## 2.3 Elevational Changes

In the following pages you will find a before and after comparison of the Submitted Scheme within Addendum Rev.A issued in June 2019 and the newly proposed scheme for the GLA.

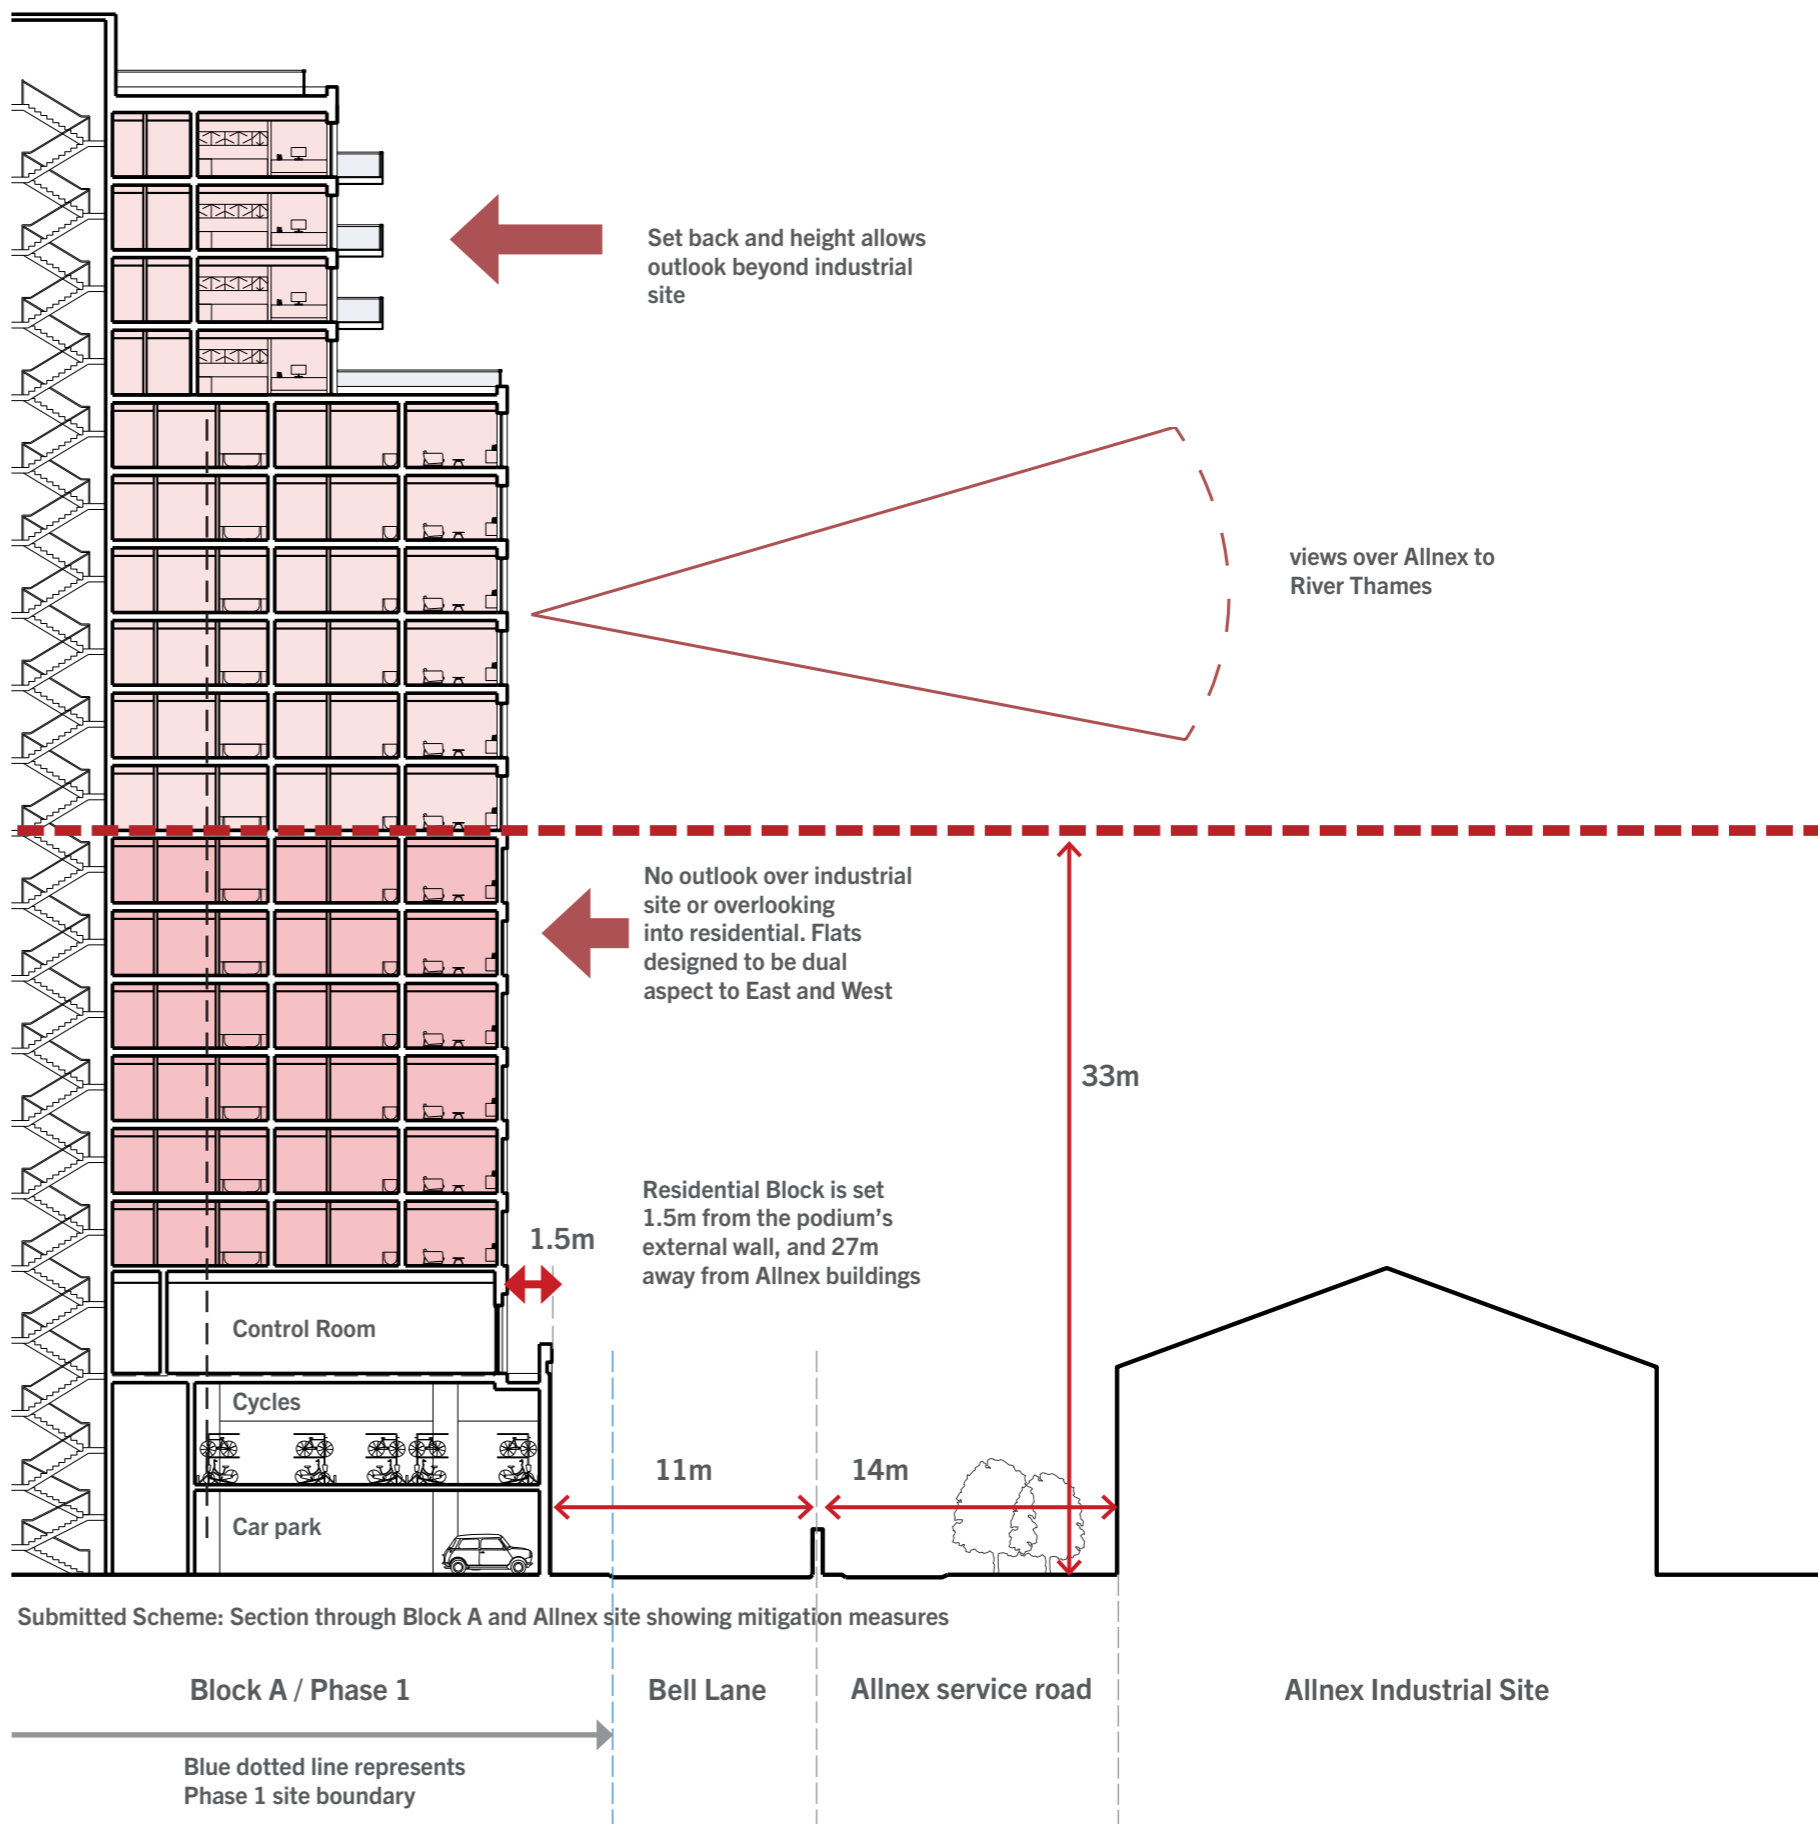
In the previous scheme, only 12 (5%) units were located adjacent to the Allnex Industrial site. 6 of these were 9 storeys above grade with panoramic views in all directions. All of these units were also planned as double aspect, facing east and west, with no direct overlooking to the industrial sites, and all mechanically ventilated.

In the amended scheme, Block A has been reduced by 6 storeys and also has been pushed further away from the Allnex site to a total of 30m. This reduces the impact onto residential units, mitigating its agency of change and responding directly to LBN's Reason For Refusal No.1.

Furthermore, units from the 8th level (10th storey) upwards have only small windows facing the Allnex site and will obtain grand panoramic views over the River Thames and Royal Docks. External private amenity is set even further at a minimum of 35m away. These balconies face east and west as before, and all units are mechanically ventilated.
